# Groundwater Transfer Review Summary Form

Transfer/PA # T- 14435

Application: T-14435

Applicant Name: Townsend HB, LLC

**Hydrograph – area wells**

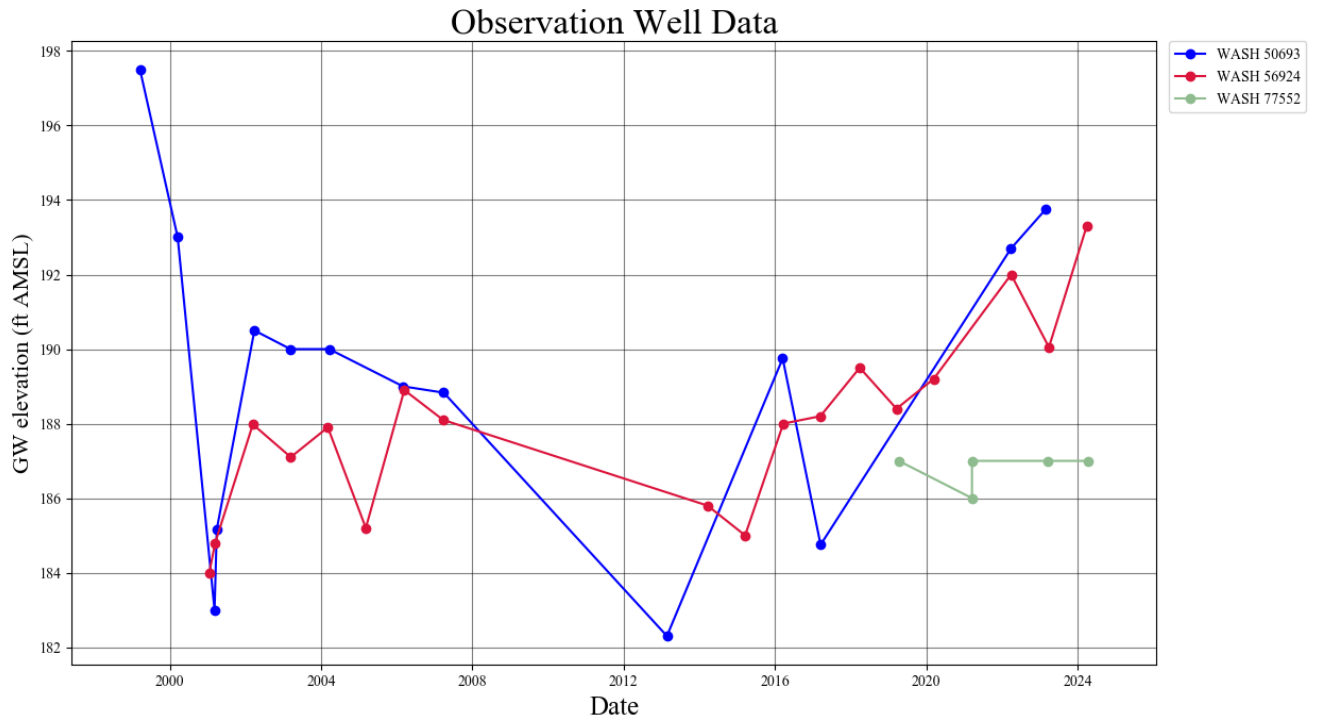
- b) If yes, for each POA identify the reference level, most recent spring-high water level, and whether an applicable permit decline condition has been exceeded: For the purpose of this review, the initial March measurement for WASH 56924 of 16.20 ft bls, obtained on 3/13/2001, was selected for this evaluation as an interim value. The most recent spring measurement was 7.70 ft bls, measured on 3/29/2024. Consequently, because this most recent measurement is higher than the provisional reference level, applicable permit decline conditions have **not** been exceeded.

- NOTE:** due to the ambiguous permit language related to setting of a reference level, there is some uncertainty about the which of the first few March water level measurements from WASH 56924 should in fact be the proper reference level. That is, the 3/13/2001 measurement was indeed the initial static well level in the well, which would satisfy the permit language; however, that measurement pre-dates the permit date of 9/17/2002, which technically marks the first authorized use of the well (i.e., does it matter if well use pre-dates authorized use?). In this particular case the differences in both time and measurement are relatively minor (i.e., only 1-2 years and a few feet, respectively). However, in many other cases these differences can be much more significant (i.e., on the order of decades and/or tens of feet) with correspondingly greater implications for using reference levels to assess decline condition triggers.

**North-South cross-section**

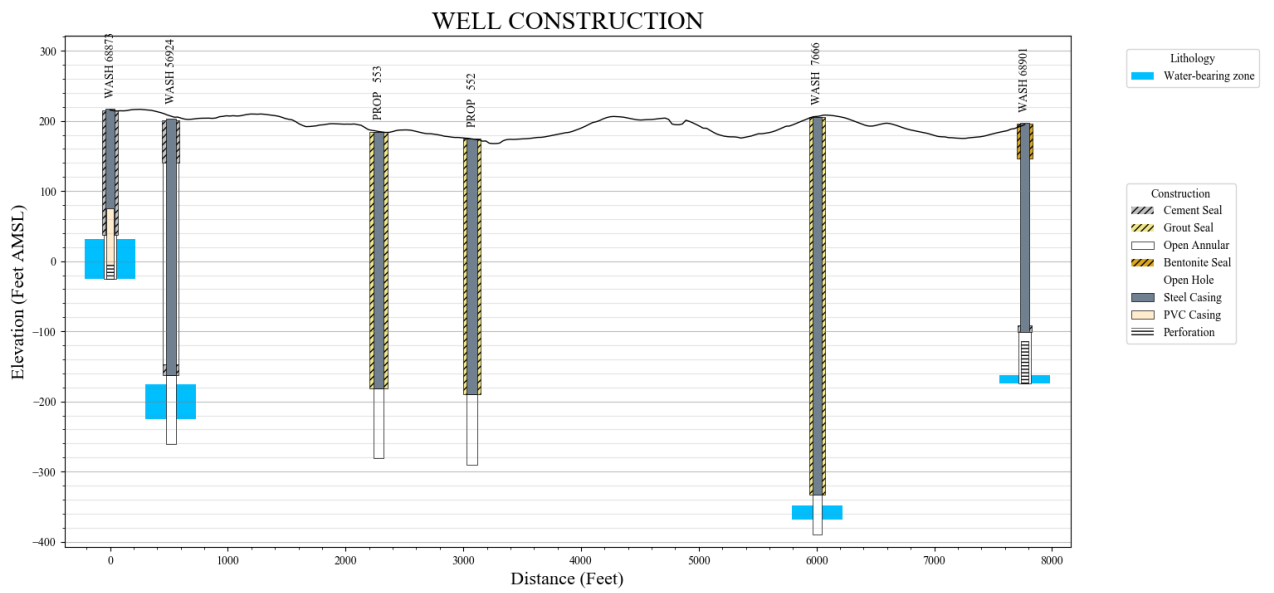
2. Will the proposed POA develop the same aquifer (source) as the existing authorized POA?  
 Yes     No    Comments: The two proposed APOA wells are planned to be approximately 465 feet deep, and cased and sealed to about 365 feet deep. These planned well construction details indicate that the proposed APOAs will obtain groundwater from the same basalt aquifer system tapped by the authorized POA, WASH 56924 (Gannett and Caldwell, 1998; Woodward and others, 1998).
